# UNITED STATES PATENT AND TRADEMARK OFFICE

APPLICATION NO.	FILING DATE	FIRST NAMED INVENTOR	ATTORNEY DOCKET NO.	CONFIRMATION NO.
10/826,073	04/16/2004	Paul A. Lindberg	83714.86249	9970
24335 7590 01/24/2008 WARNER NORCROSS & JUDD LLP 900 FIFTH THIRD CENTER 111 LYON STREET, N.W. GRAND RAPIDS, MI 49503-2487			EXAMINER CHIN, PAUL T	
			ART UNIT 3652	PAPER NUMBER
			MAIL DATE 01/24/2008	DELIVERY MODE PAPER

<b>Office Action Summary</b>	<b>Application No.</b>	<b>Applicant(s)</b>	
	10/826,073	LINDBERG, PAUL A.	
	<b>Examiner</b>	<b>Art Unit</b>	
	PAUL T. CHIN	3652

**DETAILED ACTION**

**Exhibit A**

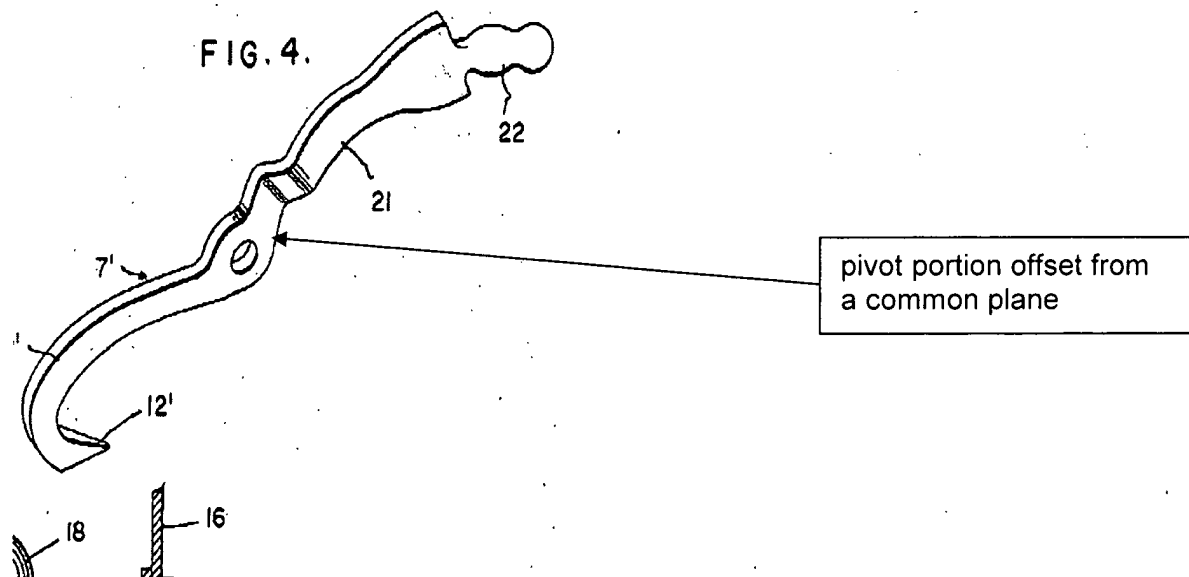
Furnia et al. (2,832,635) discloses a device for lifting an object (13), comprising:

a first arm (6) having an upper portion, a pivot portion and a lower portion, said upper portion of said first arm and said lower portion of said first arm extending in a common plane;

a second arm (7) having an upper portion, a pivot portion and a lower portion, said pivot portion of said first arm pivotally connected to said pivot portion of said second arm, said upper portion of said second arm and said lower portion of said second arm extending in said common plane wherein at least one of said pivot portion of said first arm and said pivot portion of said second arm is offset from said common plane (see **Exhibit A**) an amount selected such that said upper portion and said lower portion of said first arm and said upper portion and said lower portion of said second arm extend in said common plane; and wherein at least a portion of said upper portion of said first arm follows a first radius of curvature having a center on an exterior side of said first arm (see **Exhibit B**).

**Exhibit C**

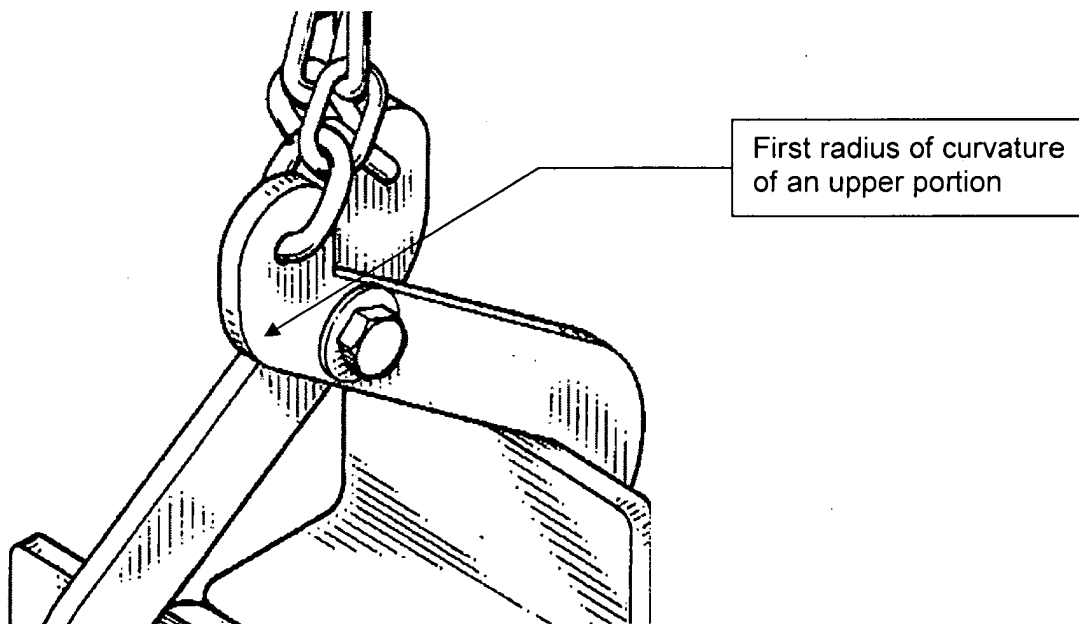
a second arm having an upper portion, a pivot portion and a lower portion, said pivot portion of said first arm pivotally connected to said pivot portion of said second arm, said upper portion of said second arm and said lower portion of said second arm extending in said common plane, and a portion of said upper portion of said first arm follows a first radius of curvature having a center on an exterior side of said first arm (See Exhibit C).

Kifer (Des. 245,972) does not show a pivot portion of one of the arms being offset from a common plane. However, Furnia (2,932,635) teaches an arm having a pivot portion being offset from a common plane of the arm. Thus, it would have been obvious to those skilled in the art to modify a pivot portion of one arm of the Kifer (Des. 245,972) to be slightly offset as taught by Furnia (2,932,635) to restraint the pivoting movement of the arms.
